## Bridge Aesthetics Committee Meeting on April 1, 2021

Cortez Road (SR 684) from SR 789 (Gulf Drive) to 123<sup>rd</sup> Street West  
Bridge Replacement Design (Manatee County)  
FPID Number: 430204-2-52-01

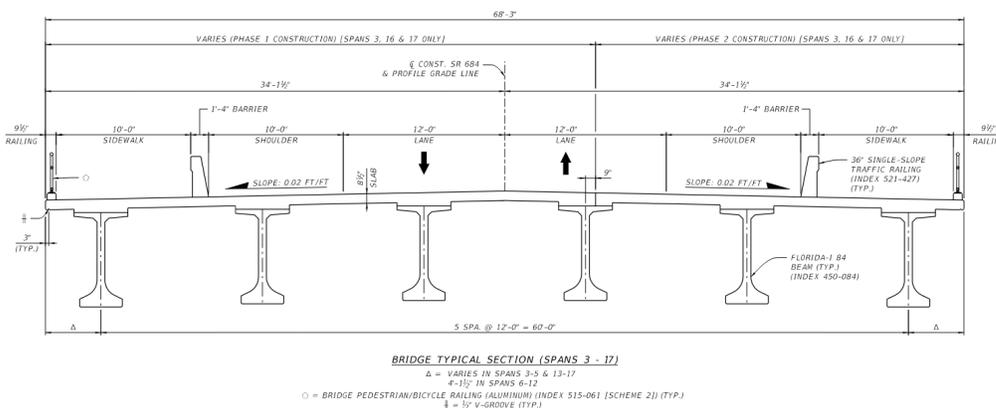
- Jeff Vey: doesn't like vertical stripes; prefers waves and schools of fish (slides 32, 33, and 36)
- Connie Morrow: doesn't like the big waves; prefers the thinner wave with schools of fish; have more sand than fish; more subtle design (slides 32, 33, and 36)
- Joe Adorna: likes the design on the top with lighter coloring on the bottom; most want "beachy" design on the wall; one with the large waves is too much; keep it subtle wave and school of fish at the top and bottom (slides 32 and 33; no community comments on slide 36)
- The project team will follow up with Ann Marie Nicholas for her input on the wall design.
